Picture: Sketch 20-1

Operation: 20

Document Number: Gas Cylinder 1100 LW

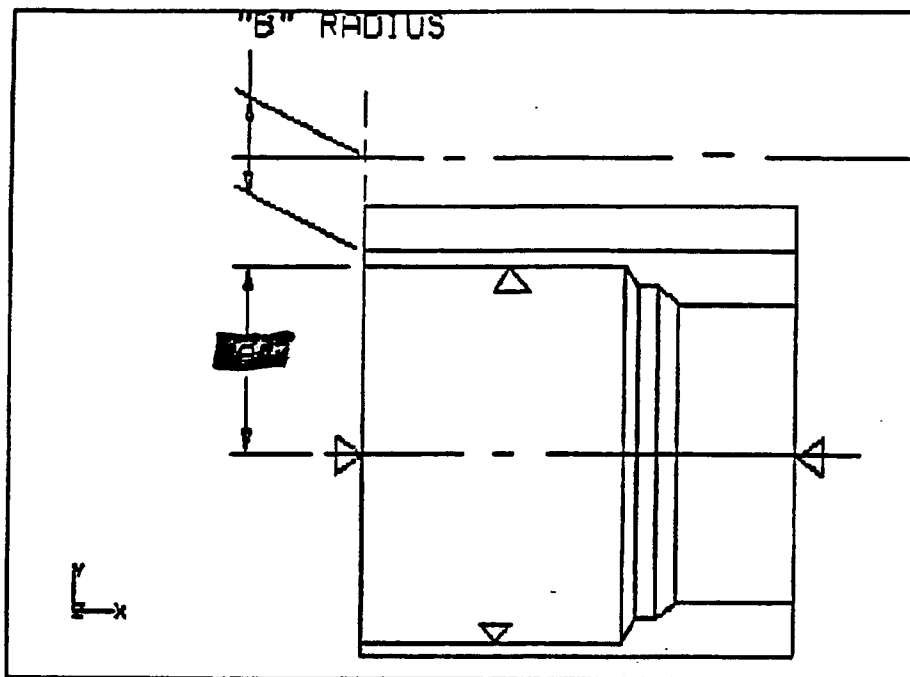
- DIMENSION "A" INCORRECTLY COPIED FROM PRIOR SKETCH.
 - HIDDEN LINES MADE SOLID; IMPLIES SECTION VIEW BUT OMITTS CROSS HATCHING. THIS MAKE VIEWER UNSURE OF WHAT IS BEING PRESENTED.
 - SOLID/OUTLINE TRIANGLES HAVE DIFFERENT MEANING IN PRIOR SKETCH. THIS INFO LOST IN NEW SKETCH.
- ⇒ IS THERE A QUALITY SYSTEM ELEMENT IN PLACE TO REVIEW THESE?
